Re: Champion Xpress
2100 Central Ave. SW
Traffic Circulation Layout
Architect's Stamp XX-XX-XX (J13-D216)

Based upon the information provided in your submittal received 3-11-22, the above referenced plan cannot be approved for Building Permit until the following comments are addressed:

CHAMPION XPRESS CARWASH

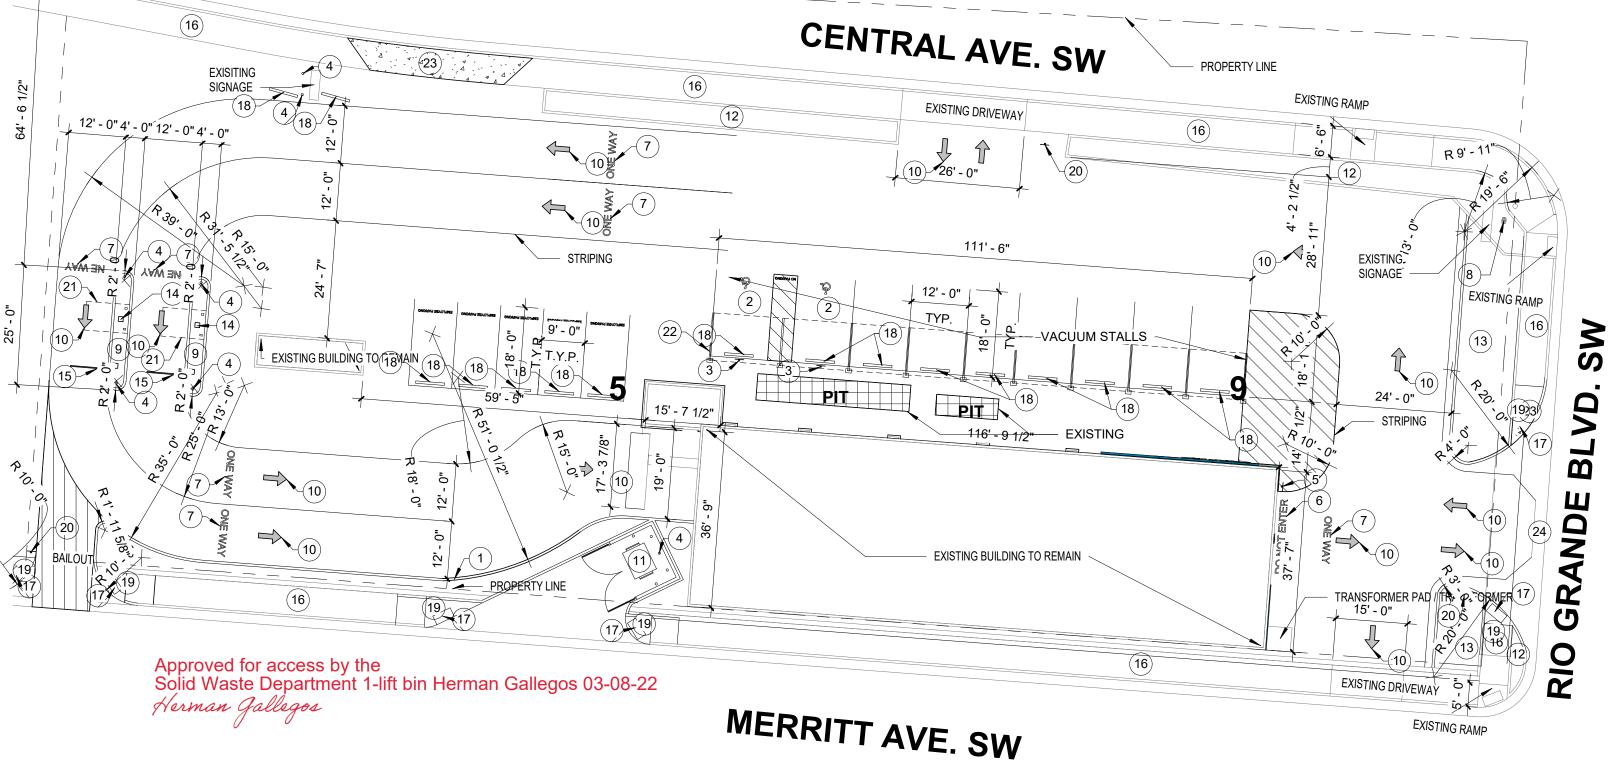
- 1. Please show a vicinity map showing the location of the development in relation to streets and well known landmarks.
- 2. List the number of parking spaces required by the IDO as well as the proposed number of parking spaces including bicycle and motorcycle parking.

- 3. The traffic circulation layout must be stamped, signed, and dated by an engineer or architect licensed in the state of New Mexico.
- 4. Identify all existing access easements and rights of way width dimensions.

- 5. Identify the right of way width, medians, curb cuts, and street widths on Central Ave., Rio Grande Blvd. and Merritt Ave.
- 6. Clarify existing property lines and proposed property lines.

- 7. Curb Return Access is recommended on Central Ave.
- 8. All existing dirvepads need to be ADA accessible. Please updated them to current standard.
- 9. Maximum access width for arterial, collector, and local streets are as follows:

- 10. Existing ramp at the corner of Rio Grande Blvd and Merritt Ave need to be updated to current ADA standard.
- 11. Provide the width for the existing sidewalk.

- 12. Provide dimensions and "Do Not Enter" sign for the BALOUT area.
- 13. Drive through facilities: Minimum 3 Vehicles stacking spaces shall be provided pursuant to Table 5-5-8 (Required Stacking spaces).
- 14. Provide ADA parking space
- 15. The minimum parking stall dimensions are:

- 16. The ADA accessible spaces must include an access aisle. Van accessible aisles should be 8ft wide; all others should be 5ft wide.
- 17. The ADA accessible parking sign must have the required language per 66-7-352.4C NMSA 1978 "Violators Are Subject to a Fine and/or Towing." Please call out detail and location of signs.

- 18. The ADA access aisles shall have the words "NO PARKING" in capital letters, each of which shall be at least one foot high and at least two inches wide, placed at the rear of the parking space so as to be close to where an adjacent vehicle's rear tire would be placed. (66-1-4.1.B NMSA 1978)

- 19. ADA curb ramps must be updated to current standards and have truncated domes installed.
- 20. Motorcycle parking spaces shall be designated by its own conspicuously posted upright sign, either free-standing or wall mounted per the zoning code.

- 25. Per the DPM, a 6 ft. wide ADA accessible pedestrian pathway is required from the public sidewalk to the building entrances. Please clearly show this pathway and provide details.

- 26. Per DPM, a 6 ft. wide ADA accessible pedestrian pathway is required from the ADA parking stall access aisles to the building entrances. Please clearly show this pathway and provide details.

- 27. ADA accessible pedestrian pathway should not be placed behind parking space or adjacent to a vehicular way. Vehicle and pedestrian/wheel chair conflicts should be avoided as much as possible.

- 28. All sidewalks along streets should be placed at the property line.
- 29. Provide a copy of Fire Marshal Approval.
- 30. It is not apparent what type of pavement surface is being proposed. A hard driving surface will be required as part of this proposed project for parking area and drive aisles.

- 31. All one-way drives shall have "One Way" signage. Please show detail and location of posted signs.
- 32. Provide "DO NOT ENTER" and "EXIT ONLY" signage for the existing drivepad off Merritt Ave.

- 33. Show the Intersection Sight Distance for Central Ave. and Rio Grande Blvd. and add the following note to the plan: "Landscaping and signage will not interfere with clear sight requirements. Therefore, signs, walls, trees, and shrubbery between 3 and 8 feet tall (as measured from the gutter pan) will not be acceptable in the clear sight triangle.

- 34. Show the clear sight triangle for Merritt Ave. and add the following note to the plan: "Landscaping and signage will not interfere with clear sight requirements. Therefore, signs, walls, trees, and shrubbery between 3 and 8 feet tall (as measured from the gutter pan) will not be acceptable in the clear sight triangle.
